UNITED STATES
NUCLEAR REGULATORY COMMISSION
WASHINGTON, D. C. 20555

Note to the Files

MARK III POOL SWELL IMPACT LOAD PROFILE FOR SMALL STRUCTURES

MARK III POOL SWELL IMPACT LOADS

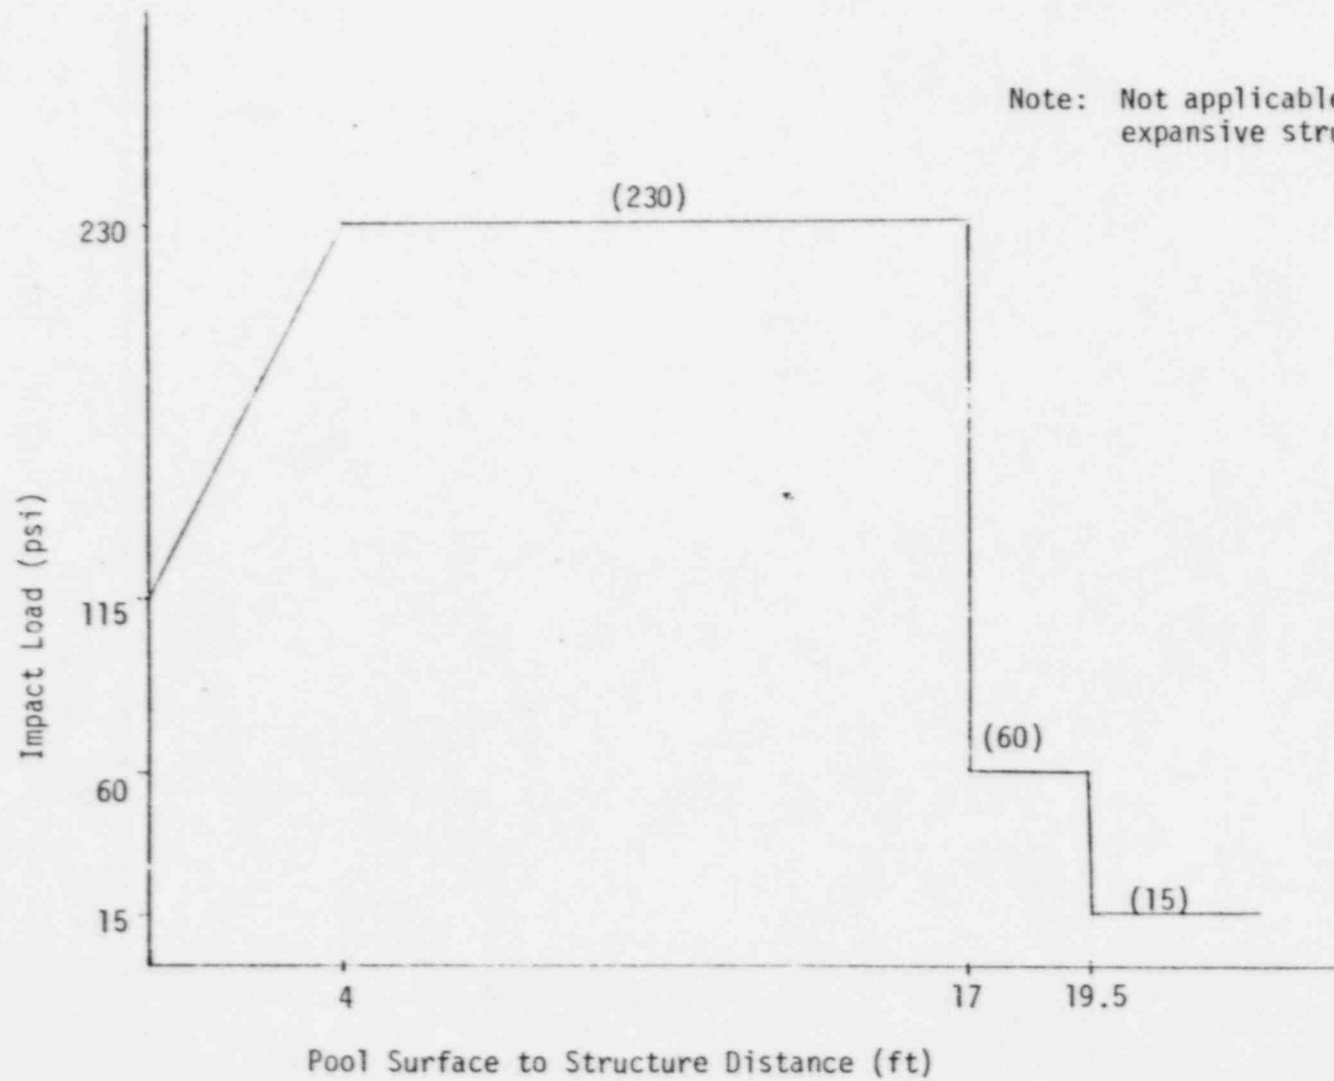
A pool swell impact load profile for plants utilizing Mark III containments (Attachment A) was developed in the course of our review of pool dynamics for the Grand Gulf plant. This profile specifies pool swell impact loads for structural design purposes as a function of elevation above the suppression pool surface and is applicable to small structures such as pipes, I-beams, and components. Use of the profile by an applicant would constitute an acceptable basis upon which to proceed at this time with design and construction of the affected structures. The development of this profile was based on the Mark III pool dynamics test data currently available to the staff; i.e., the full-scale air tests (Series 5706) and Phase A of the one-third scale steam tests (Series 5801, 5802, 5803, and 5804). Following our receipt and evaluation of additional data from GE, including that from recently proposed one-third scale air tests, the values specified in the profile could be subject to adjustment. The following discussion delineates the basis upon which the profile was developed.

Considering first the region of solid water impact, data from air test 5706/4 indicated a load of 115 psi at 4 feet clearance and 10 feet vent submergence. Based on level probe data the pool surface velocity at impact was found to be approximately 20 ft/sec.. For actual plant conditions we are interested in impact loads at various elevations with an initial vent submergence of 7.5 feet. Therefore our first consideration was to adjust the 115 psi data point to allow for the lesser submergence. A constant pool momentum relationship was assumed: $M_{10} V_{10} = M_{7.5} V_{7.5}$ where the subscripts refer to vent submergence. This results in a surface velocity at 4 feet elevation of $V_{7.5} = \frac{M_{10}}{M_{7.5}} V_{10} = \frac{10}{7.5} (20) = 27 \text{ ft/sec.}$

GE has indicated that a general conclusion from Phase B of the one-third scale tests is that solid water impact loads are approximately a linear function of pool surface velocity. This leads to a pool swell load of $\frac{(27)}{20} (115) = 155 \text{ psi}$ at 4 feet elevation for the higher pool velocity. Additional extrapolations must be made to determine loads as a function of elevation above the pool. Results from the one-third scale tests, which used steam blowdowns, provided the necessary data. (Air tests only provide pool motion data to about 8 feet elevation.) For a representative submergence (7.5 ft) and drywell pressure (35 psia) the following pool surface velocity data were generated:

Again assuming that solid water impact load is a linear function of pool velocity, the following values are found:

load @ 4 feet	155 psi
load @ 12 feet	264 psi

Clearly, application of these assumptions results in a continuously increasing impact load from the pool surface up to the point of breakthrough. This approach has been tempered to a degree by examination of the drywell air carryover rate. Although pure air carryover might be hypothesized to occur immediately following vent clearing, significant steam/water entrainment would be expected with time due to the decreasing inventory of air in the drywell and the large masses of steam and water being added to the drywell volume. Therefore, in establishing the load profile a linear rise from 115 psi at the pool surface to 230 psi at 4 feet and a flat ceiling of 230 psi over the range of 4 to 12 feet is specified. This profile envelopes impact loads from 0-10 feet assuming pure air carryover but allows for a less severe charging rate, based on our best engineering judgment, at higher elevations.

Examination of the pool swell event indicates that the relatively high impact loads associated with solid water impact occur up to a point where the water ligament degenerates and breakthrough of the air bubble occurs. GE has selected an elevation of 12 feet (1.5 x submergence) for the onset of transition loading on the basis of air test 2. We have evaluated the data from the air test and particularly the one-third scale tests and find that our best estimate of the breakthrough data points would indicate a value of 2 times submergence while a bound of the data would require a factor of 2.5. We have selected an elevation of 17 feet which is 2.3 times the submergence as a compromise value which is reasonably conservative.

The pool impact load in the transition region was found by extrapolating air test data in a similar manner to the solid impact loads. From the previously cited one-third scale steam test, the pool velocity at 17 feet elevation was determined and then multiplied by $\frac{27}{20}$ to predict the velocity with pure air

injection beneath the pool. This resulted in a velocity of about 54 ft/sec at the 17 feet elevation. Examination of air test 2 shows that the pool velocity at target impact was about 27 ft/sec, and resulted in a load of 30 psi. To adjust this load for the higher velocity the assumption was made that load was a linear function of velocity in the transition region as was the case in the solid impact region. The resultant transition load is therefore 60 psi.

The third region of pool swell impact loads is that attributable to froth impingement. As mentioned above, the results of air test six were interpreted to yield a design value of 15 psi for this condition. Further comprehensive testing for this type of impact was accomplished in Phase A of the one-third scale tests and indicated loads ranging from 2 to 7 psi. Based on these results and the margin provided by a design value of 15 psi we were able to concur in this load specification.

MARK III POOL SHELL IMPACT LOADS GE RECOMMENDATIONS

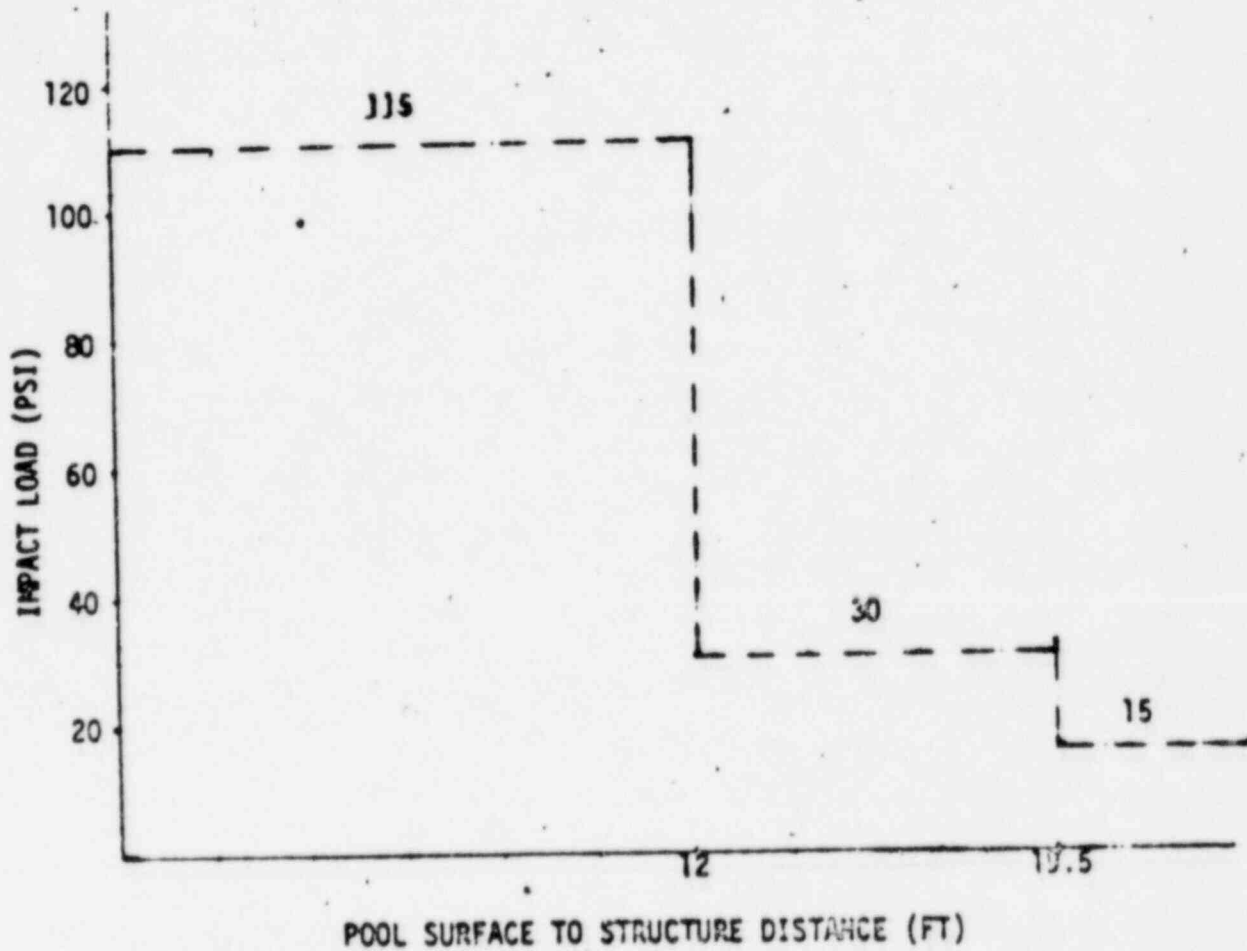
The General Electric Company had previously developed a similar profile of pool swell loads which was given to A/E's as recommended values for design purposes. This is shown in Attachment B. The GE profile recognizes three zones of impact loading; the first from 0-12 feet specifies 115 psi due to solid water impact; the second from 12-19.5 feet specifies 30 psi due to solid water/froth transition impact; the final zone for above about 19.5 feet specifies 15 psi due to froth impingement. The justification for this profile is dependent to a large degree on test data not currently available to the staff. Therefore, our profile, while maintaining three phases of pool swell impact, does reflect different parameter values due to a difference in the data bases or interpretation of the data which is available.

Recognizing certain differences in the froth conditions at impact for tests 5706/5 & 6 and those expected in an actual plant, GE recommended the application of a factor of three to the measured load, 5 psi, to arrive at a design load of 15 psi.
